## **Product Change Notification**

Date: July 13<sup>th</sup>, 2017

T-55787GD104-LW-AGN (TCG104SVLQ\*PNN-AN\*37)

Fig. 1 : Current: 10pcs (1rowx10pcs), 11kg

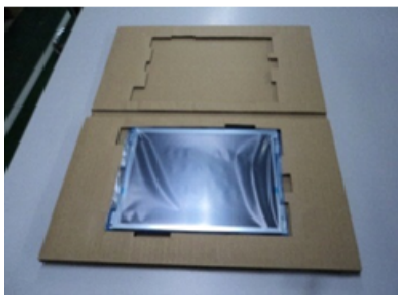
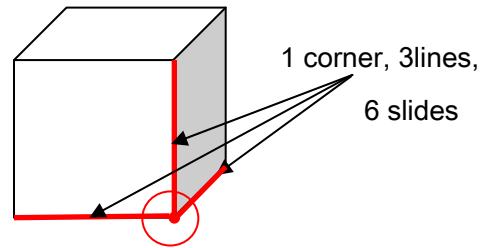
As part of improving production efficiency in our China factory, we propose a packaging change on the above mentioned product by increasing the box quantity from 10pcs per box to 20pcs per box. The new package will maintain the same drop test standard, and the part number will remain the same.

*Fig. 2: New: 20pcs (two rows x 10pcs), 13.5kg*
